8.0 PROPOSED CHANGES TO TECHNICAL SPECIFICATIONS

Amdt to OL/Change to Tech Specs #125, Suppl #6: Consisting of revisions to Appendix A with regard to ECCS modifications.....

PLANT NAME: Yankee Rowe

Figure 8-1

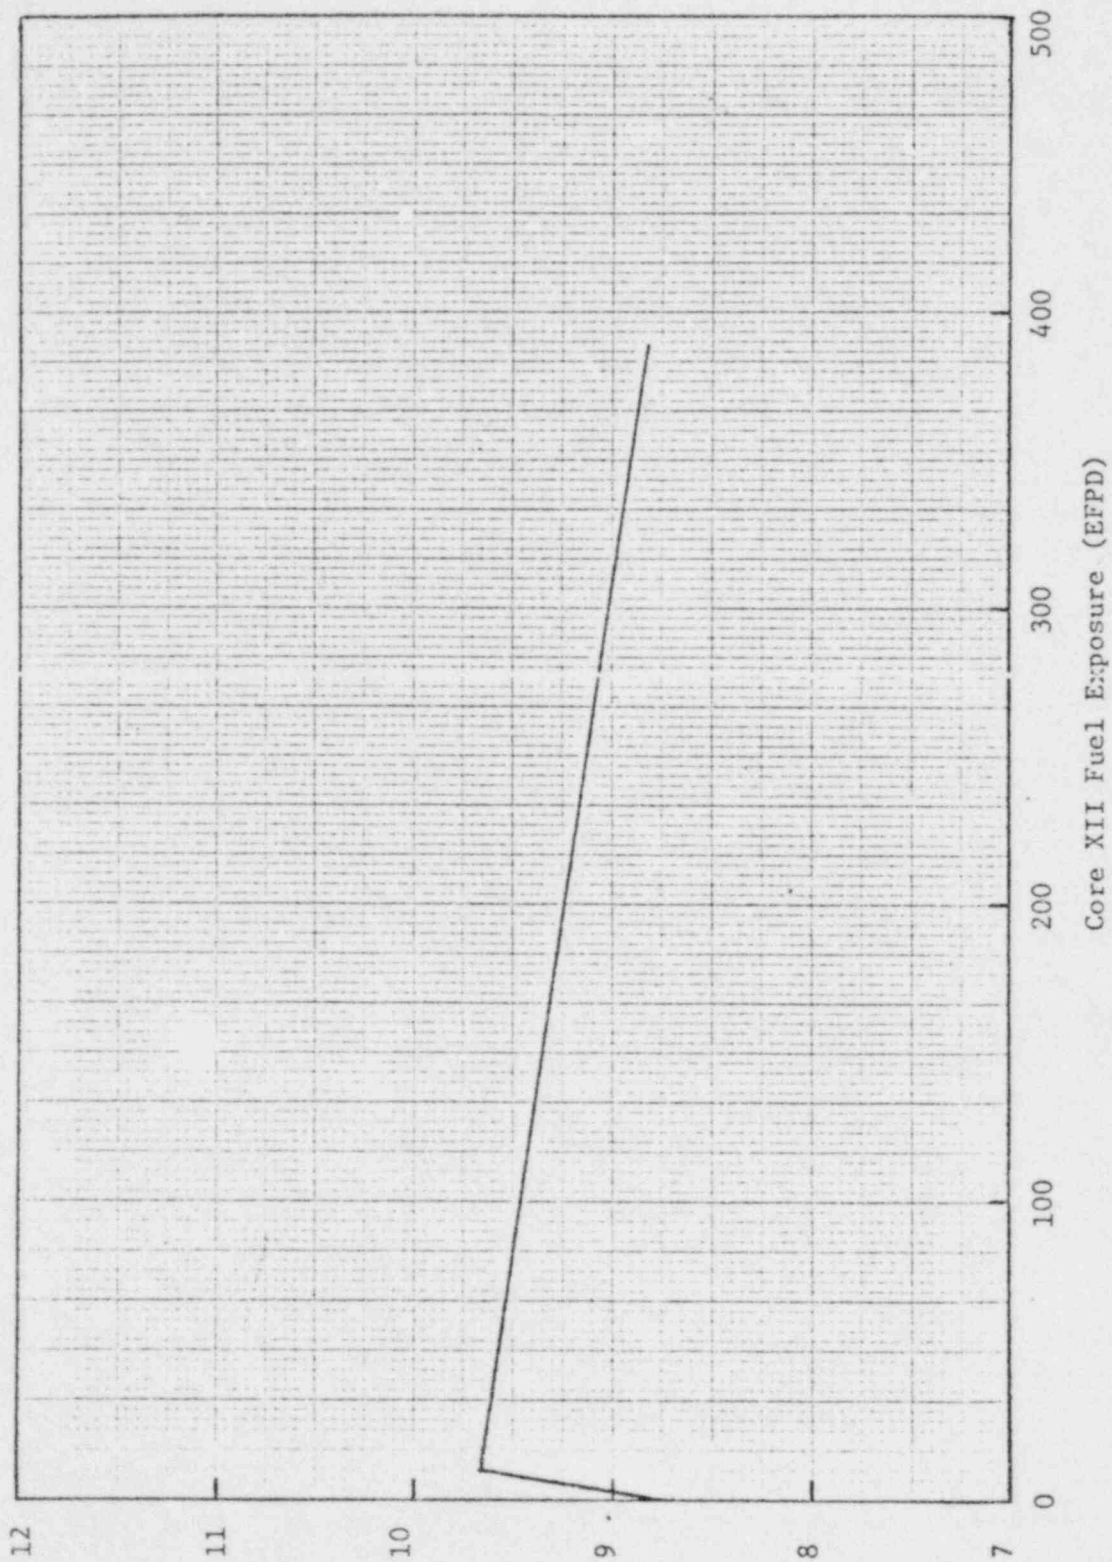
- "(1) During steady state power operation, the peak linear heat rate shall not exceed the limits shown in Figure 8-1. With these limits, if full power cannot be attained, the allowable fraction of full power shall be calculated as follows:

where the limiting LHGR is obtained from Figure 8-1. The peak full power LHGR shall include the following:

Figure 8-2

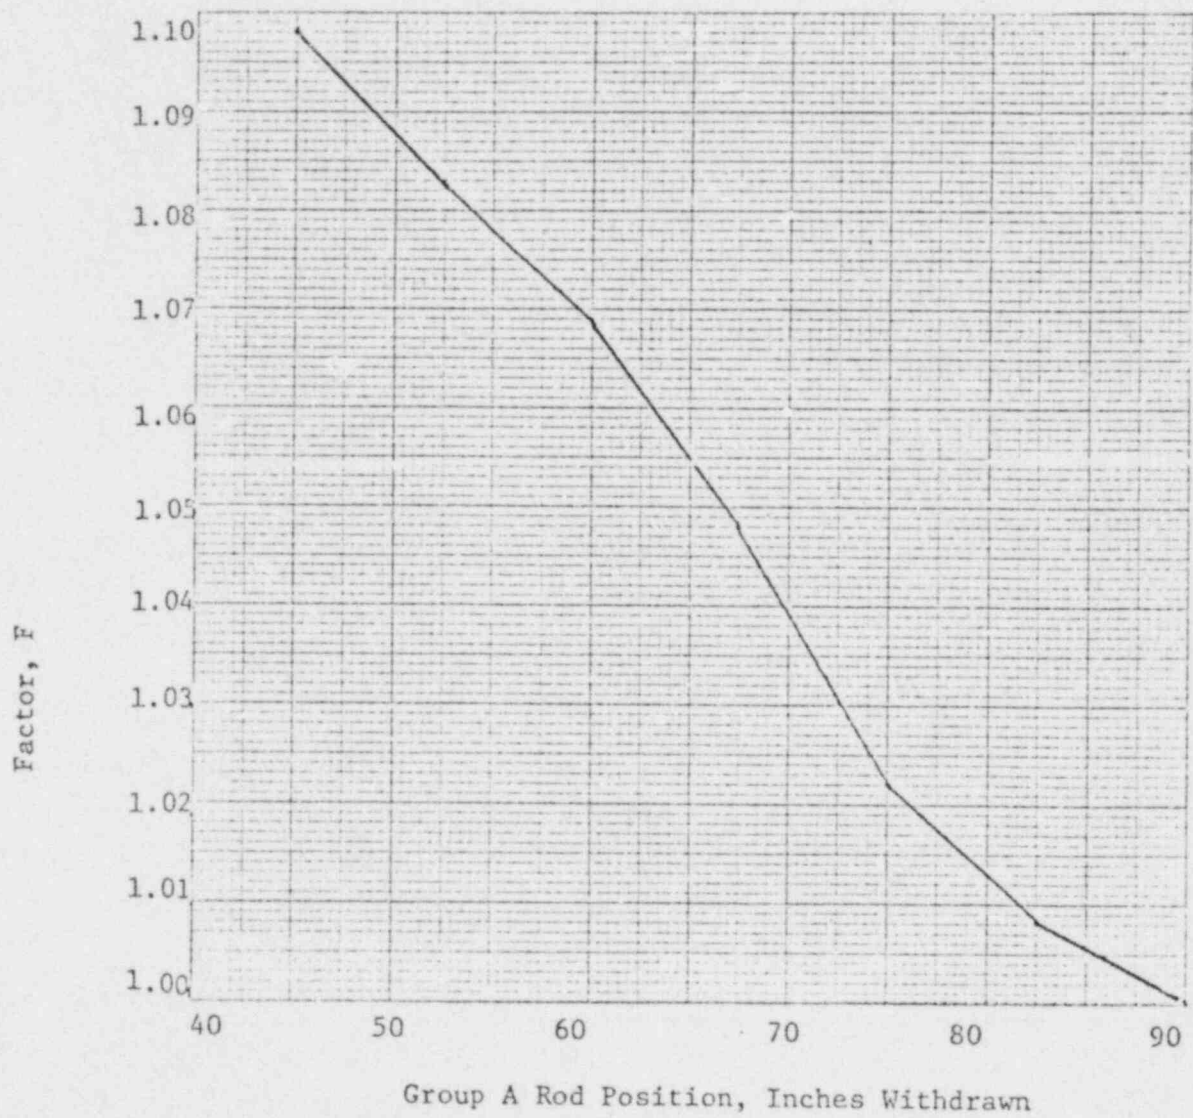
- a) Heat flux power peaking factor, F_q^N measured using core instrumentation at a power $\geq 10\%$;
- b) Effect of inserting the control bank from its position at the time of measurement to its insertion limit (F_I) as shown in Figure 8-2. The rod insertion limit is shown in Figure 8-3;
- c) Effect of xenon redistribution (1.10);
- d) Shortened stack height factor (1.009);
- e) Measurement uncertainty (1.05);
- f) Power level uncertainty (1.03);
- g) Heat flux engineering factor, F_q^E , (1.04);
- h) Core average linear heat generation rate at full power (4.34 kw/ft).
